# TECHNICAL BULLETIN INDEX

## TECHNICAL SERVICE BULLETIN

NO. 183-001

**SUBJECT:** MATCHED CYLINDERS AND PISTON (A95060)

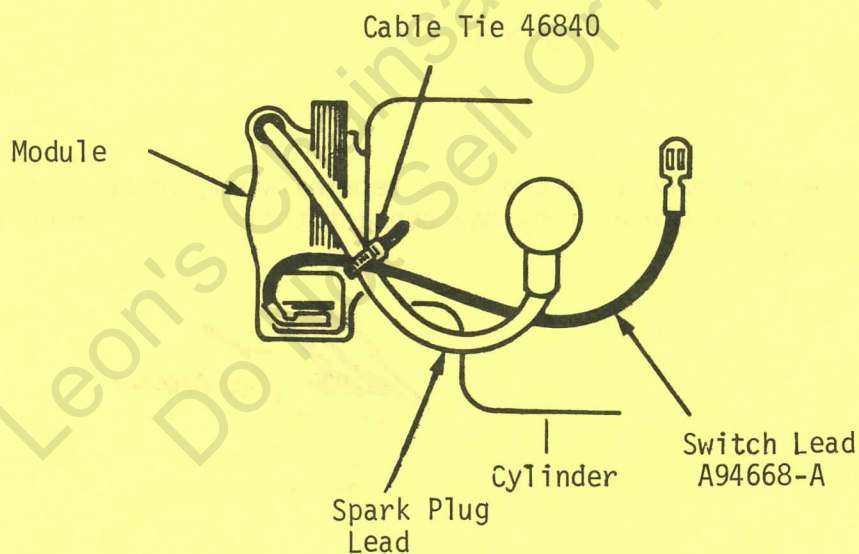
If a 330 should "die out" or "misfire" while cutting (particularly when underbucking), it may be because the muffler is coming into contact with and burning through the switch wires.

When this occurs it is because these wires are not routed properly.

Below is an illustration showing the correct routing of the switch wire #A-94668-A from the module to the switch.

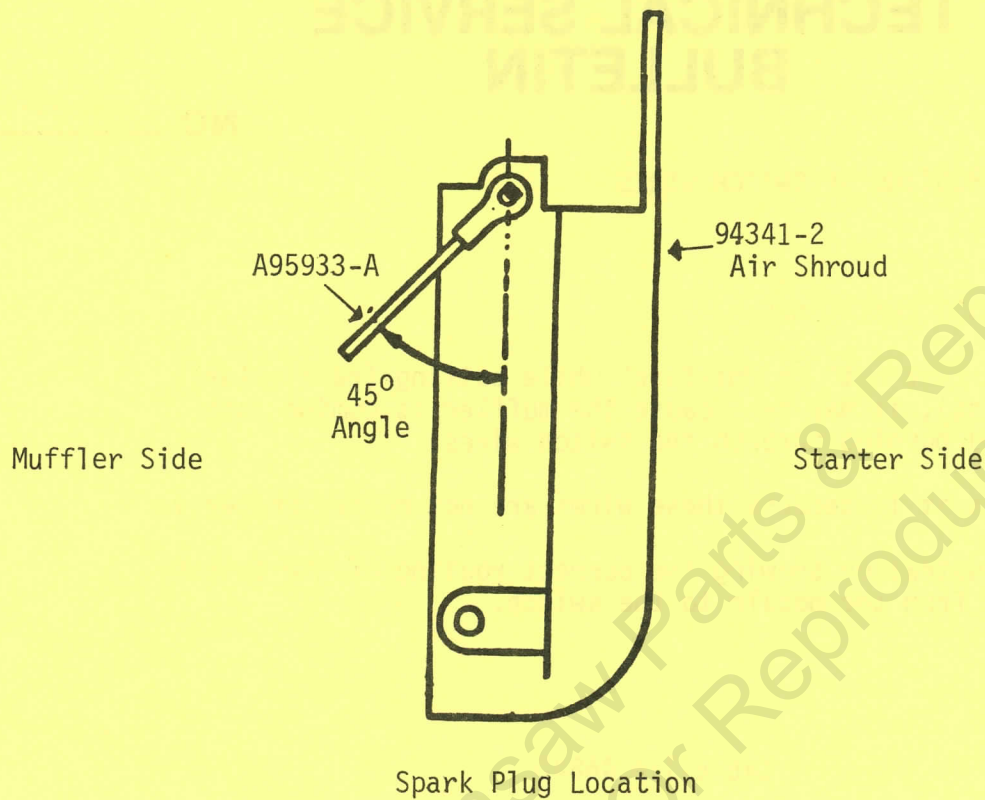
Another illustration indicates the correct position of the switch ground wire #A-95933-A.

NOTE: The on-off switch spade lugs and wire terminals should be positioned as straight as possible or they may contact the cylinder or muffler during operation.

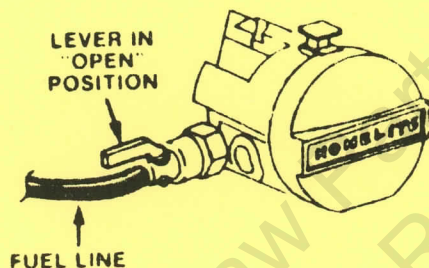
A new fuel shut off valve A-97117 (pictured below) is being incorporated into the above mentioned string trimmers.

In order to use this valve the fuel lines have been shortened. Fuel line 93157-24 (6", 152mm) is replaced by fuel line 94772-22 (5½", 140mm) on the ST-80 and ST-100. Fuel line 93157-27 (6 ¾", 171mm) is replaced by fuel line 94772-25 (6¼", 158mm) on the ST-120.

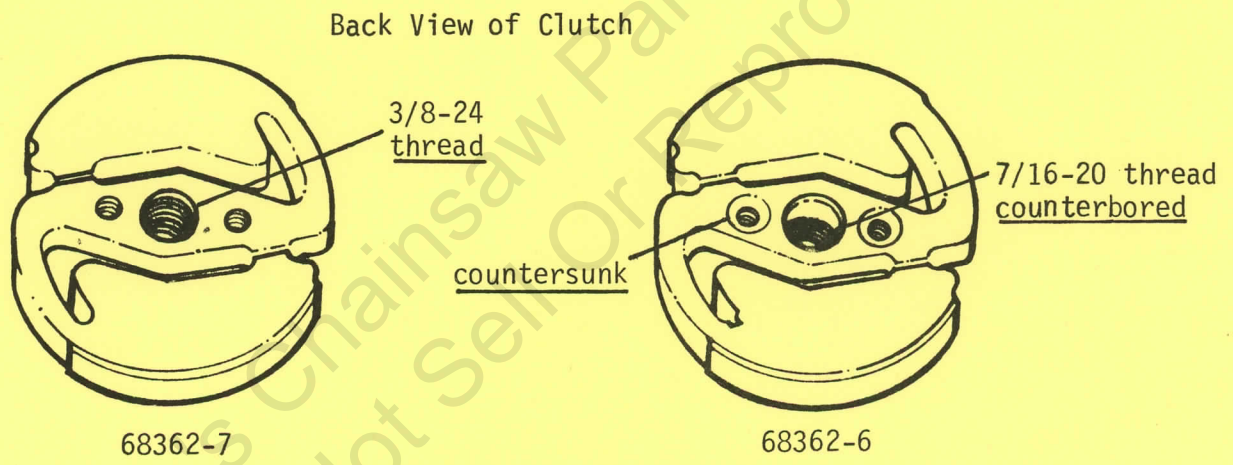
Some packages marked 68362-7 contain clutches part number 68362-6. The 68362-7 is for the 150 and SEZ-A0. The 68362-6 is for the 240.

Use the illustrations and descriptions below to identify each clutch.

68362-7  
 Center hole 3/8 - 24 thread tapped all the way through  
 Clutch cover holes 10 - 32 thread tapped all the way through

68362-6  
 Center hole 7/16 - 20 thread counterbored  
 Clutch cover holes 10 - 32 thread countersunk

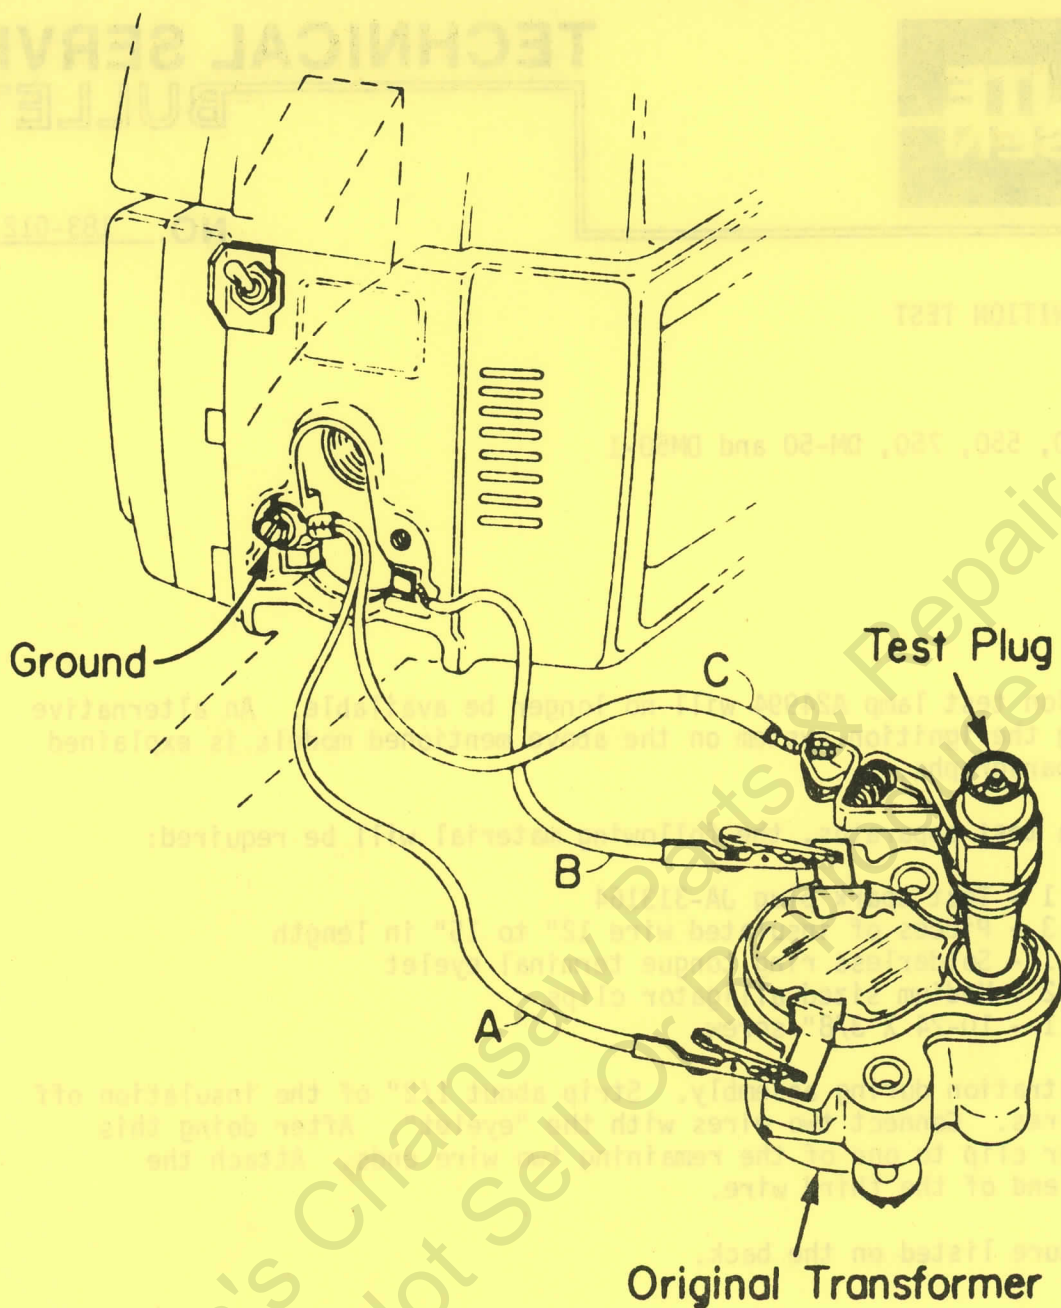
Refer to the illustration during assembly. Strip about 1/2" of the insulation off each end of the wires. Connect two wires with the "eyelet". After doing this attach an alligator clip to one of the remaining two wire ends. Attach the other clip to one end of the third wire.

1. Refer to the illustration for proper wire hook ups.
2. Note that wire "B" is placed underneath the receptacle tab.
3. If the type of test plug shown is not available make one by breaking the ground electrode off of a new spark plug. Skin more insulation off the test lead and wrap it around the plug threads.
4. Push the switch to the run position and pull the starter rope briskly.
5. If a spark is seen replace the test plug with the original plug and retest.
6. If no spark is seen with the test plug substitute a new transformer for the original and retest.
7. After completing step 6 and still no spark is evident, suspect a bad module, loose connections or a faulty switch.

Figure A

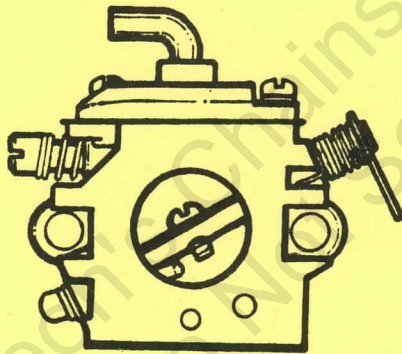
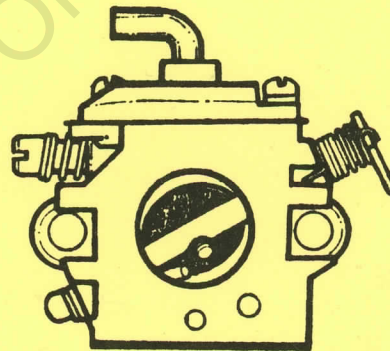
If the cable is out of adjustment, the trimmer will not reach maximum speed and the string will not advance. Also, it may stall and "die-out" at wide open throttle.

With the trigger fully depressed remove the air filter cover and observe the carburetor venturi. A properly adjusted cable stops the throttle shutter in the center of the venturi. See Figure A. A cable that is not adjusted properly allows the shutter to travel past center which creates first, maximum R.P.M.'s and then reduced R.P.M.'s. See Figure B.

Figure 1

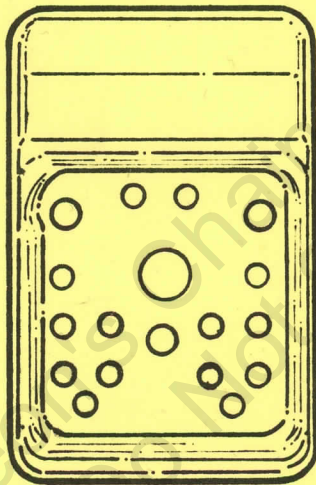
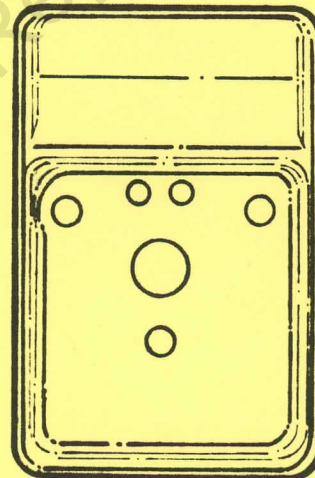
A special muffler cap (See Figure 2) was designed to meet the lower noise levels required by the French government. Some of these caps were placed on saws that were shipped within the United States.

If a new 410 sounds muffled or has low power it may contain the wrong muffler cap. The correct cap is pictured below in Figure one.

The cap shown in Figure 2 is to be used in France only.

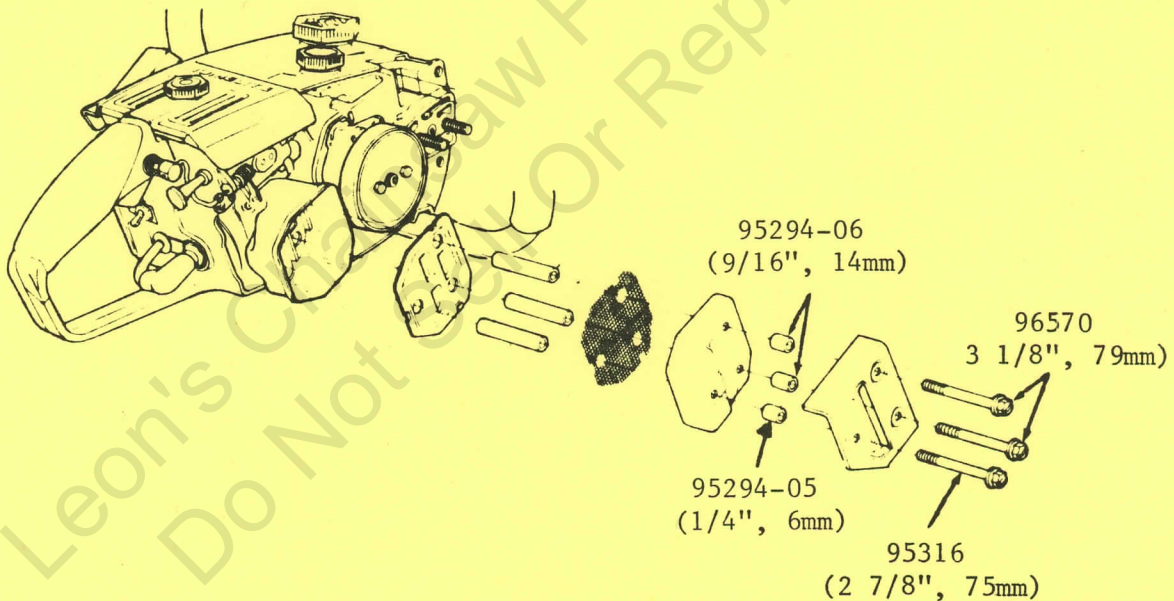
In order to decrease the temperature of the muffler deflector, the distance between the muffler deflector and the muffler cap was increased. This was done by lengthening the two existing spacers and adding a third spacer.

The illustration below indicates the part numbers of the new spacers and longer screws necessary for this change.

OLD DESIGN

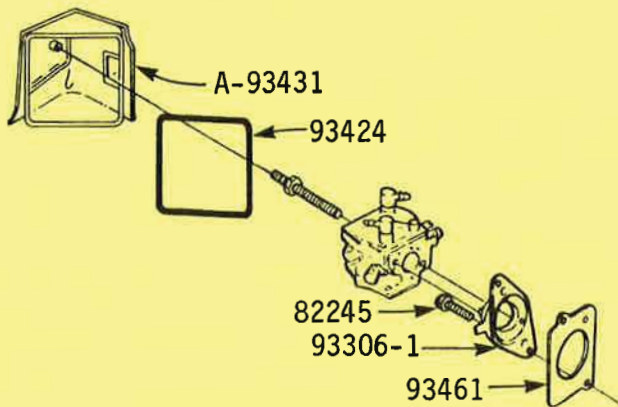
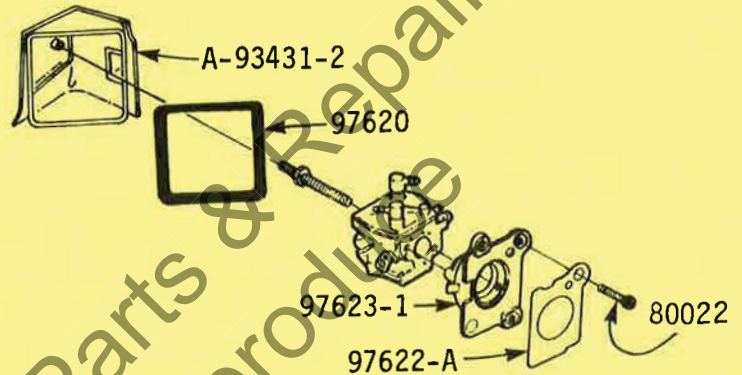
2. Improved Sealing of Carburetor Chamber - In order to substantially reduce the amount of sawdust entering the carburetor chamber, two major changes were made. The cover sealing gasket was enlarged and an extra fastener and a gasket were added to the carburetor adapter. See illustrations for details and part numbers.

Shaded areas indicate "cut-out" corners.

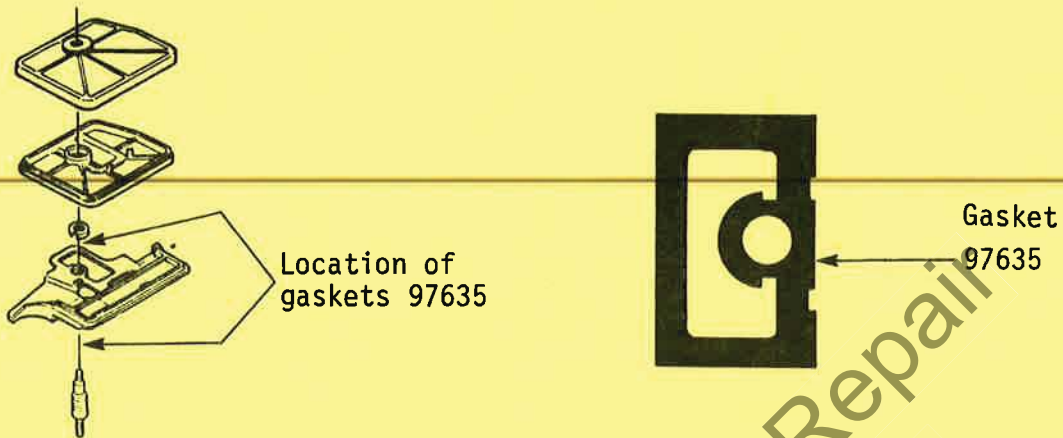
When assembling the new gasket 97620 to the carburetor cover note that the two "cut-out" corners are to be placed at the top of the cover. See Illustration.

A bead of cement 22788 should be used to retain the gasket to the cover.

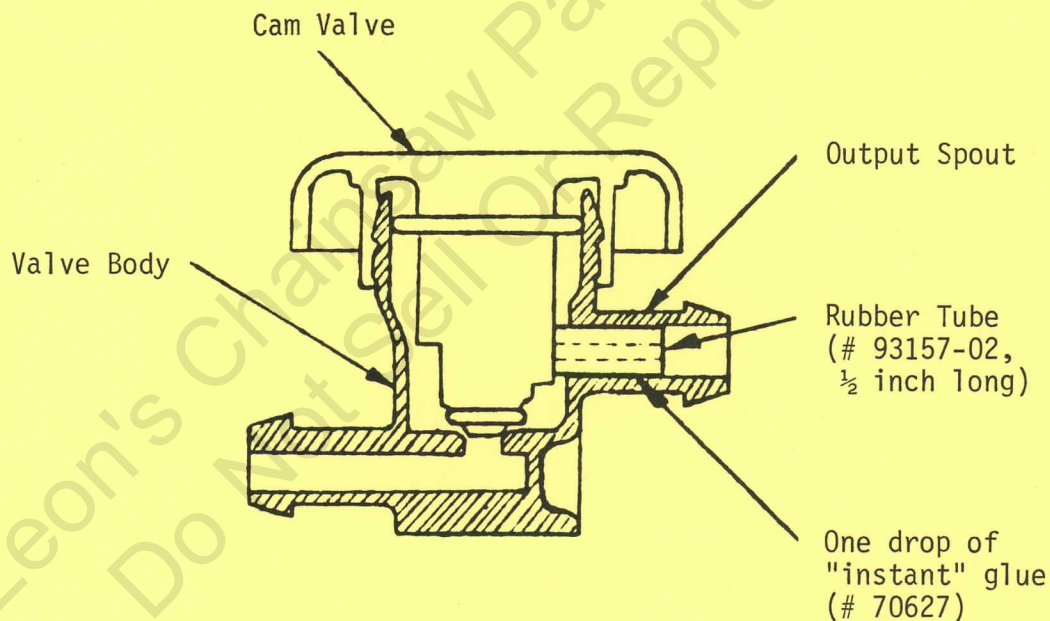
We have had reports that the fluid tank on our HB680 empties too fast for certain applications. Enclosed is a cross section picture of the control valve with a piece of tubing (part number 93157-02) in the output spout. A tank of fluid will last twice as long by installing this tube in the valve. Be sure to install the rubber tube as described below.

With the cam valve in place, align the number 1 on the valve cap with the output spout. Insert the rubber tube until seated. Apply one small drop of "instant" glue (part number 70627) between the rubber tube and the inner wall of the output spout.

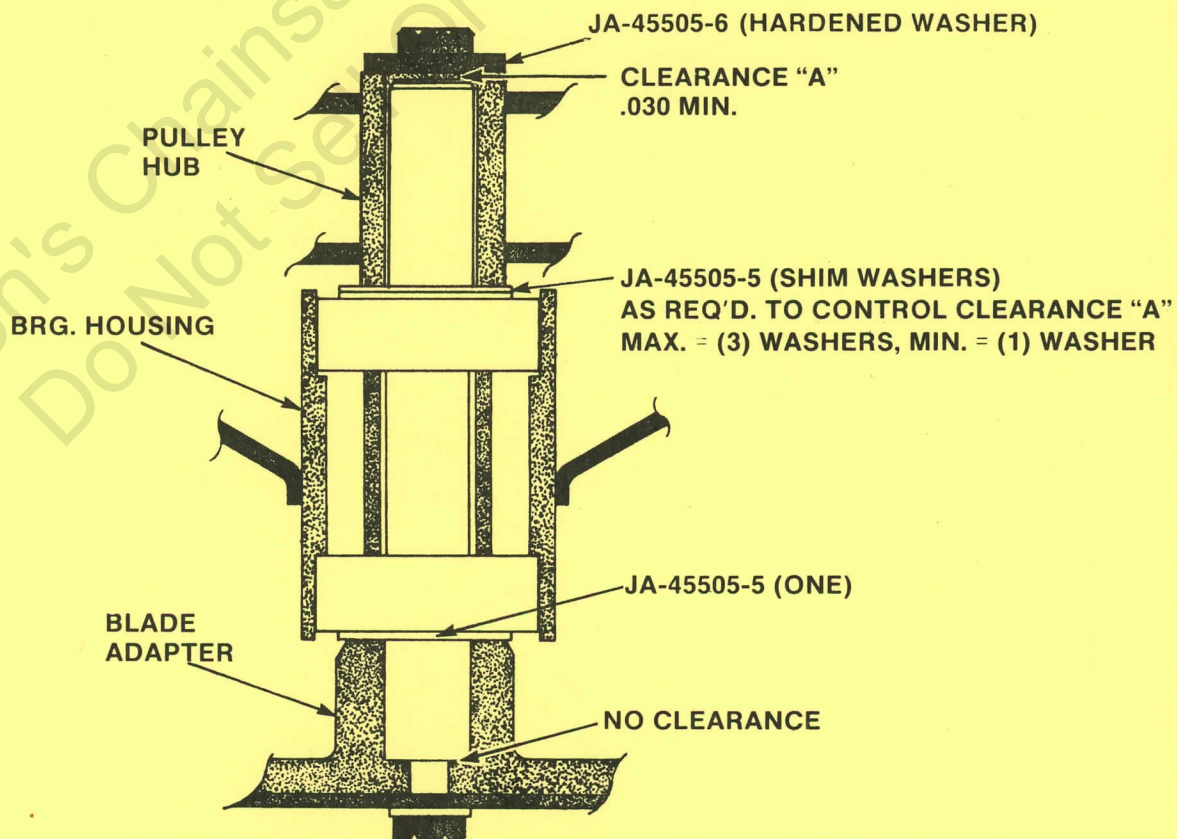
Manufacturing tolerances have allowed some center arbors to be produced with loose pulleys. To correct the problem shim washers have been added between the pulley and the bearing. The washer on top of the pulley has also been changed to a hardened washer.

1. Install blade adapter and key on arbor shaft and secure with lockwasher and bolt. Tighten bolt to 35-40 ft. lbs. Check for presence of one shim washer.
2. Install 2 shim washers on upper arbor shaft.
3. File any burrs that may be on the pulley hub. Install pulley on arbor shaft.
4. Check to see that the arbor shaft is at least .030" below the pulley hub. If shaft is above pulley hub add another shim washer.
5. Install key and secure pulley to shaft with lockwasher, bolt and hardened washer. Tighten bolt to 35-40 ft. lbs.
